LOGOS Apparels Ltd.(New buildings)

TELIRCHALA, MOUCHAK, KALIAKOIR, GAZIPUR
(24.016202, 90.305371)

29th January 2019 & 5th February 2019

Observations

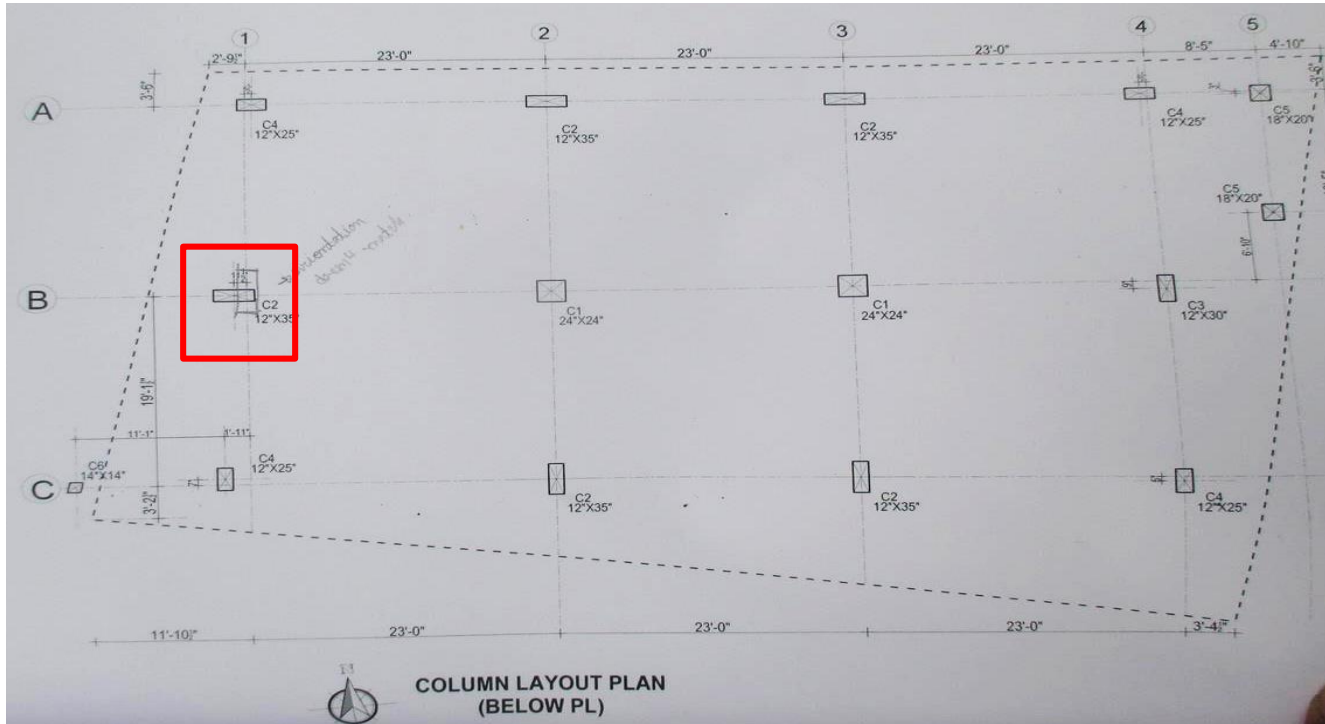
Roof slab constructed with brick aggregate. Water proofing membrane is required to be applied with proper slope.

Column Layout Plan

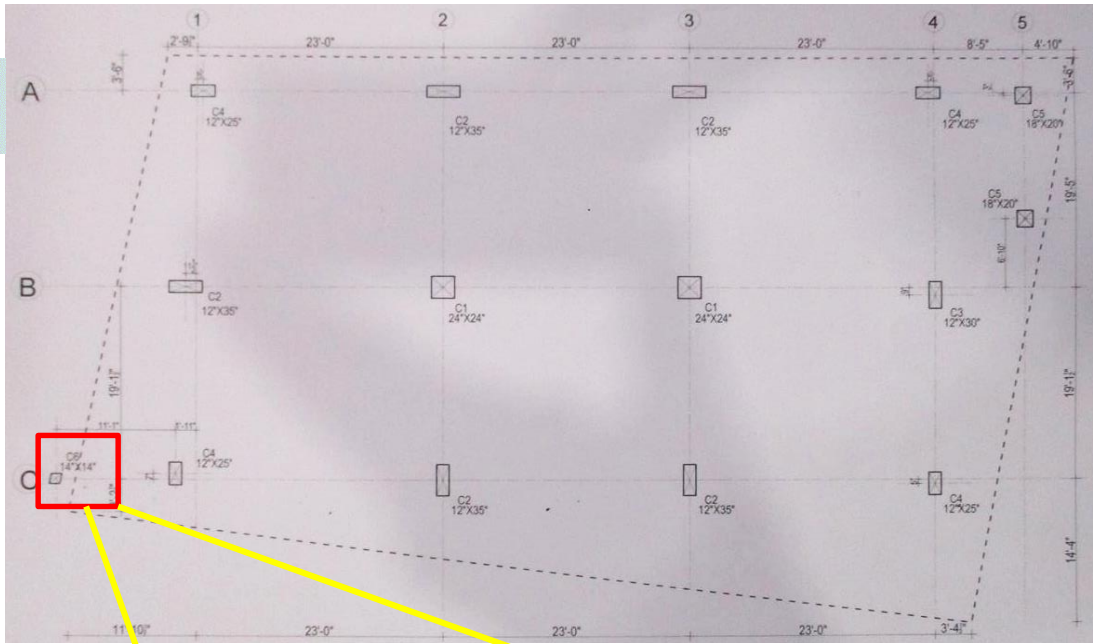
Orientation of column layout at grid- B/1 does not match with actual site condition

Column schedule

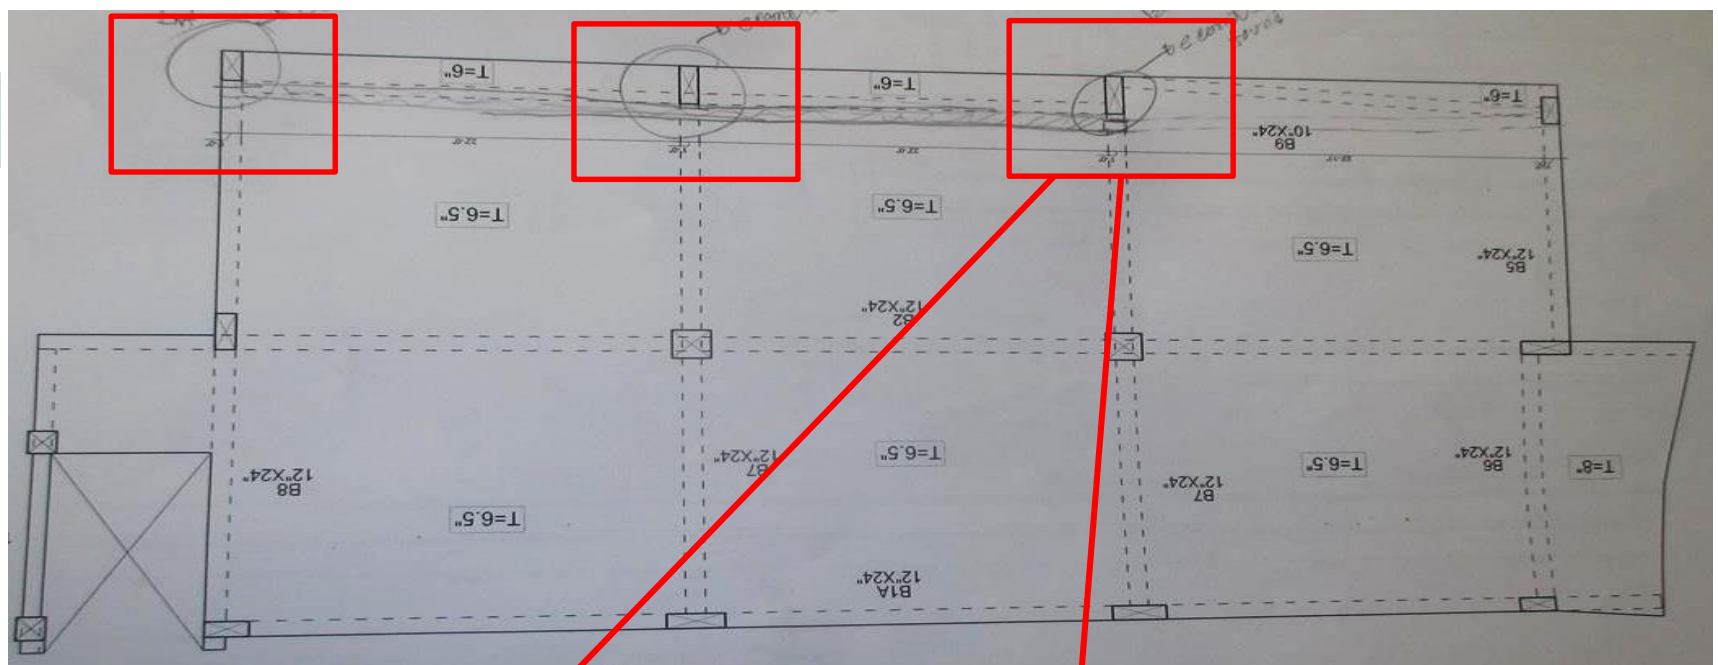
C6 column was found at basement level only but shown up to roof level in as-built drawing.

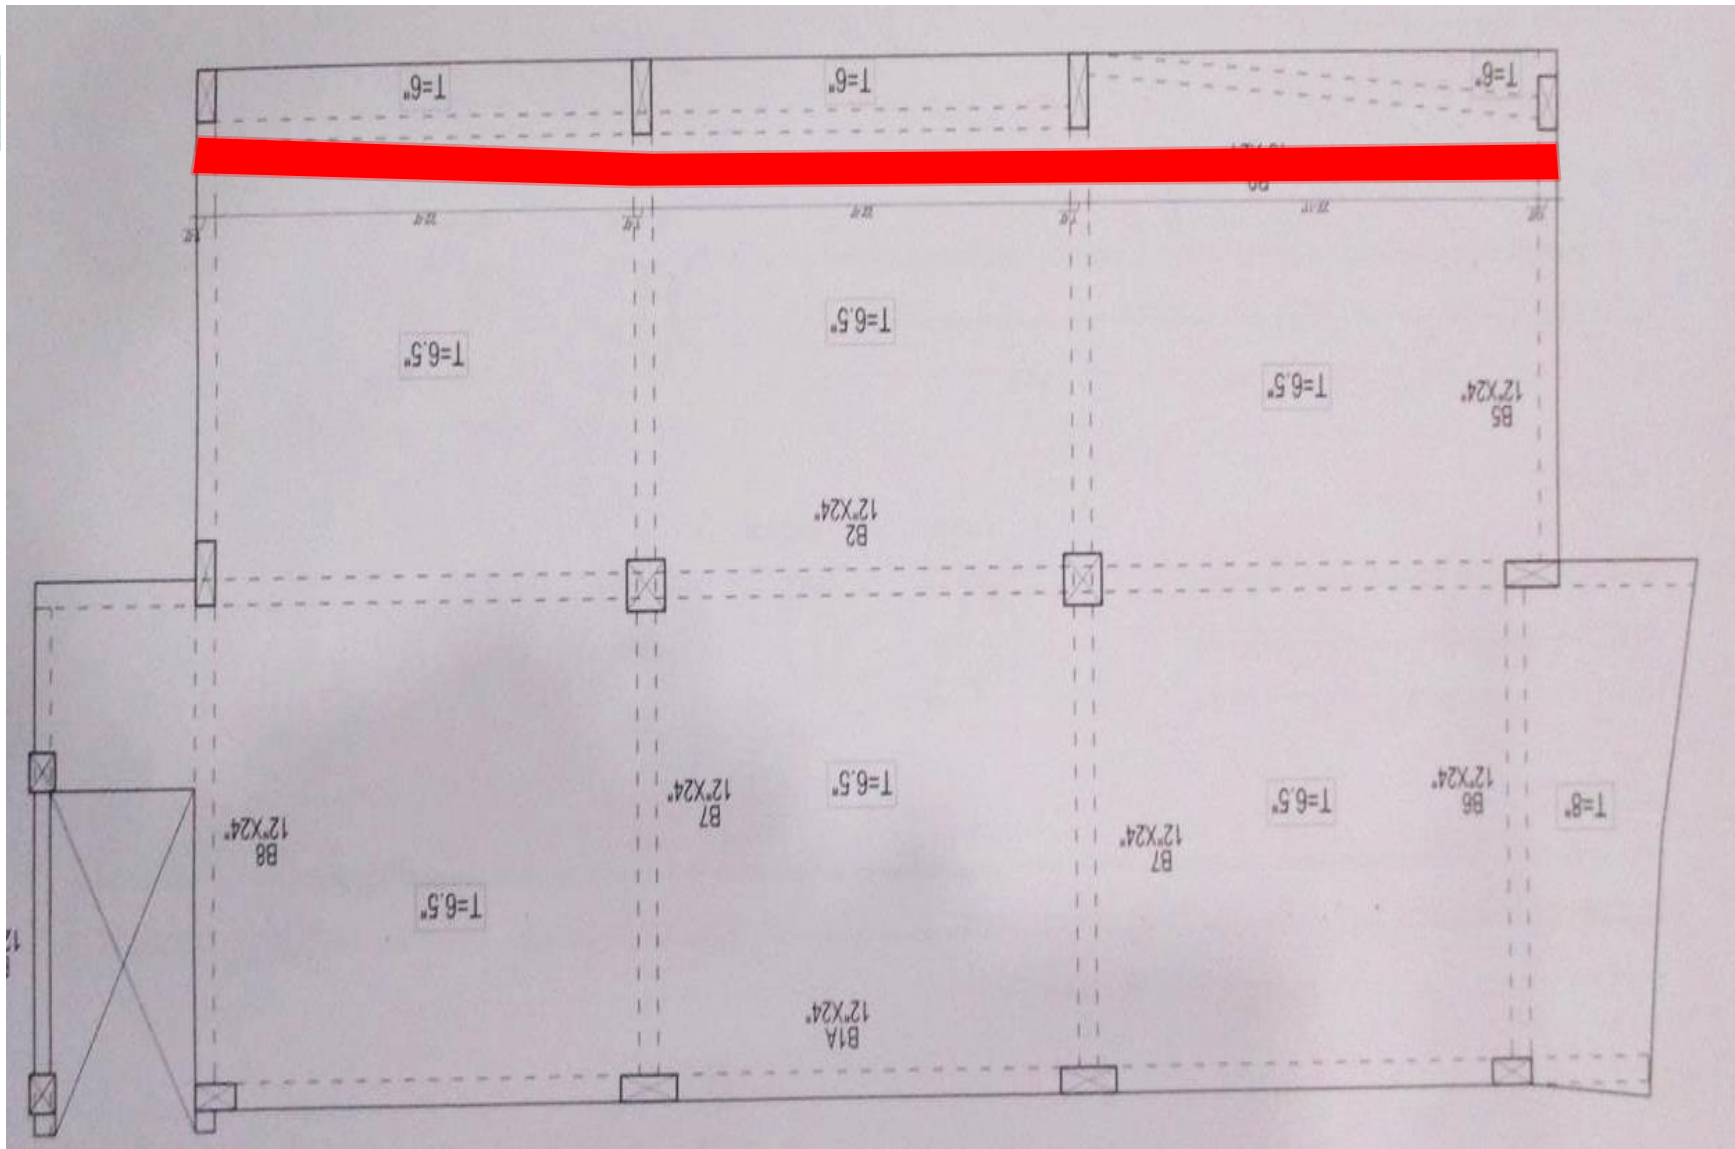
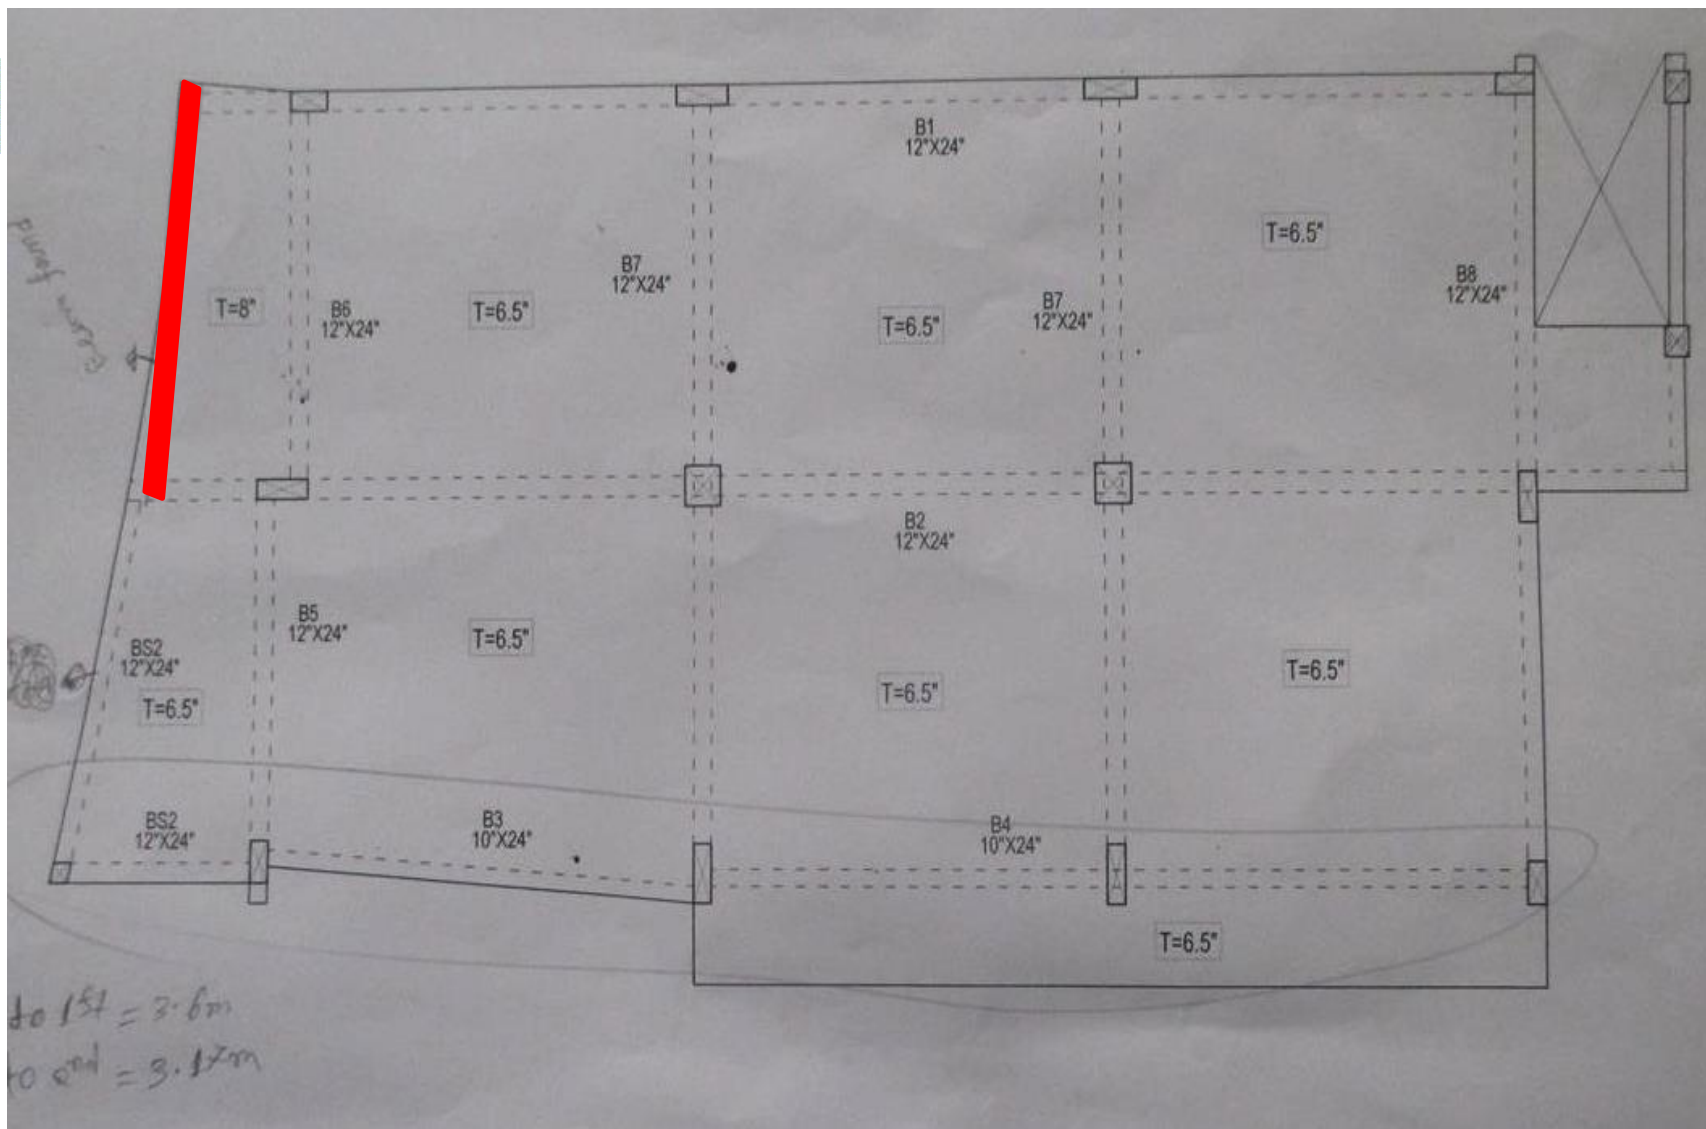
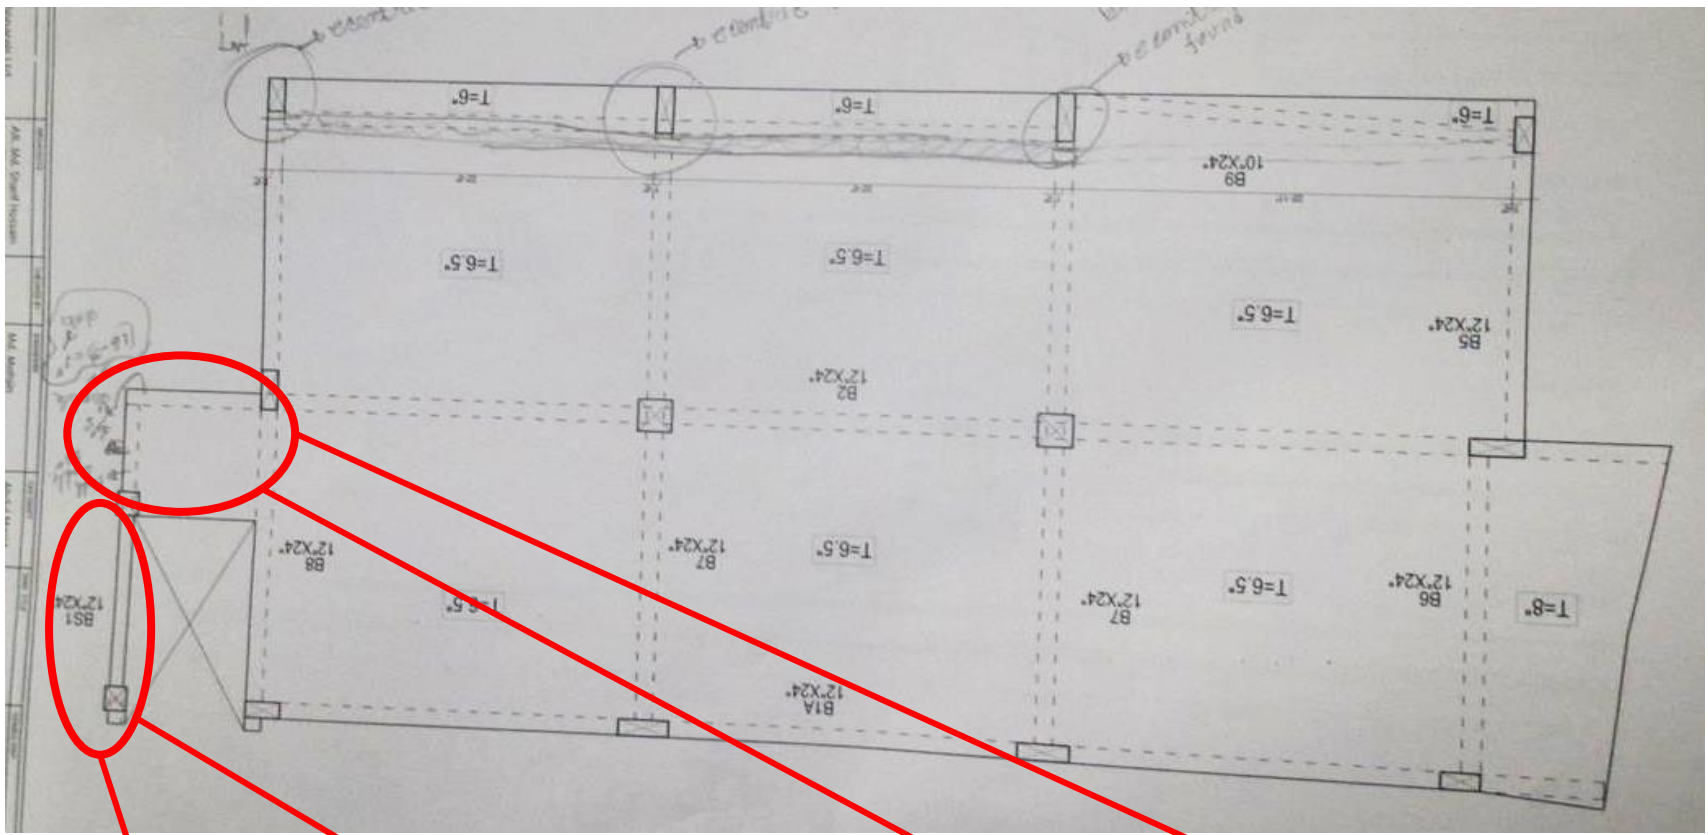
Eccentric connection at beam-column joint (marked Locations)

Beam layout Plan

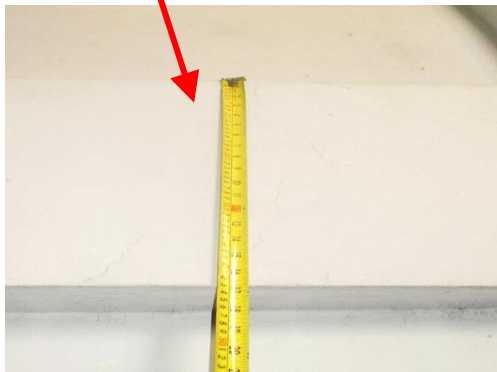
Full Depth
found 400 mm
instead of 600
mm

Down stand
depth of Beam
was found
250mm.

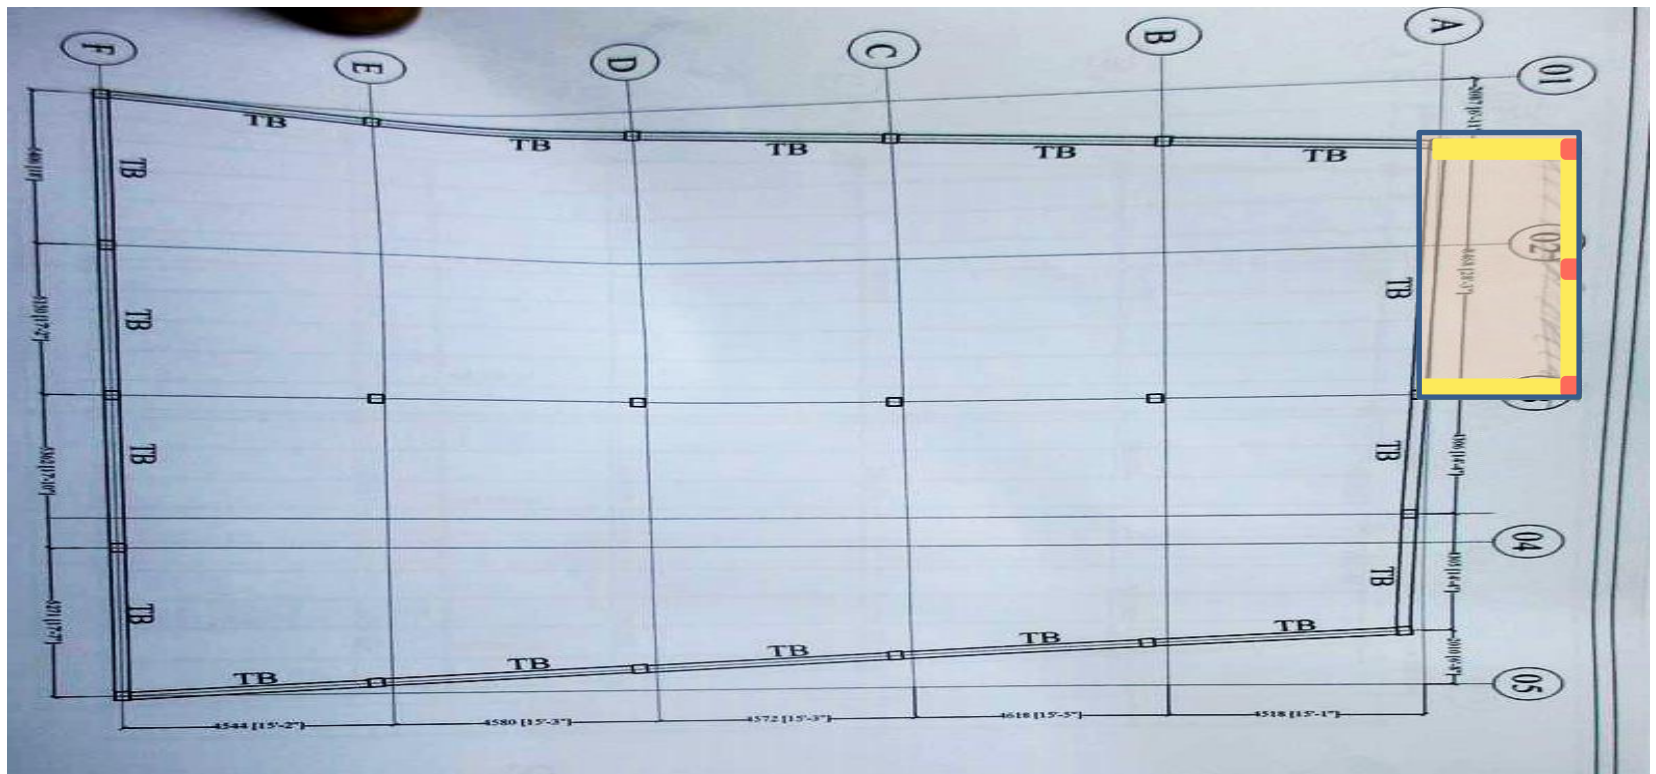
Full set of as-built drawings was not available at site. Factory engineer is required to survey and prepare all necessary as-built drawing.

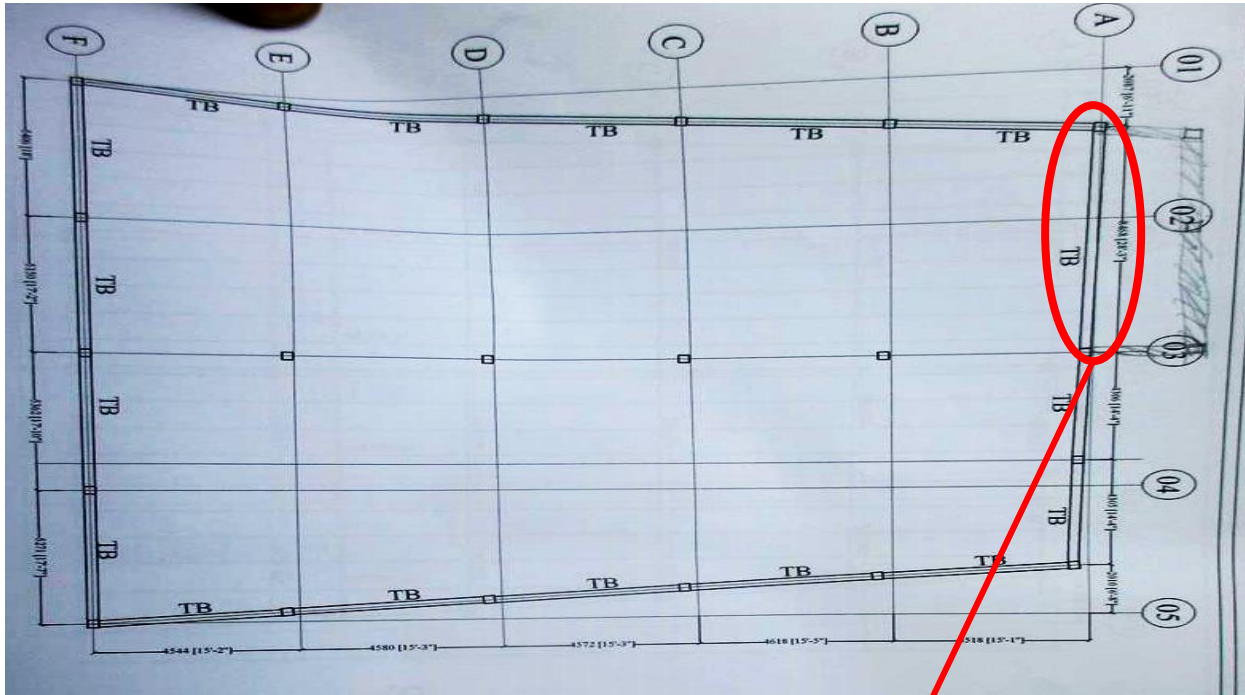
Extended shaded portion is not shown in as-built drawing.
